**PLAN COMMISSION PC #22-015
Holladay Properties Self Storage
401 W Golf Road
Round 2**

CivWorks Responses in red italics dated 01-13-2023

VILLAGE OF ARLINGTON HEIGHTS WATER METER PIT SPECIFICATIONS

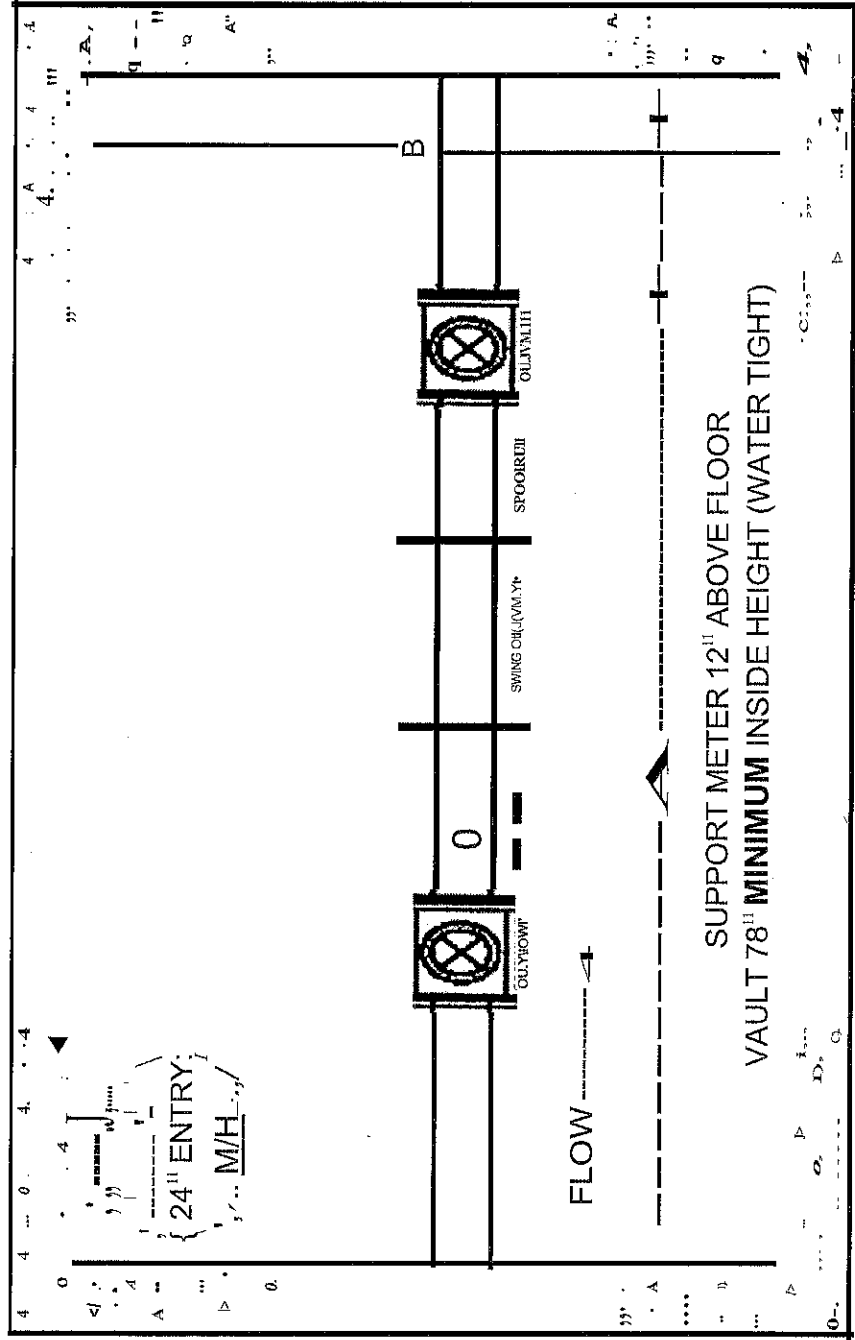
39. Install the new meter pit with new valves on the existing 6" service line to the fire hydrant.
The new fire meter pit location has been adjusted as requested.
40. Remove the old check valve in the existing vault.
The old check valve is called out to be removed.
41. Use the attached diagram for the fire line meter pit.
The fire line meter pit diagram has been updated on Sheet C6.1.
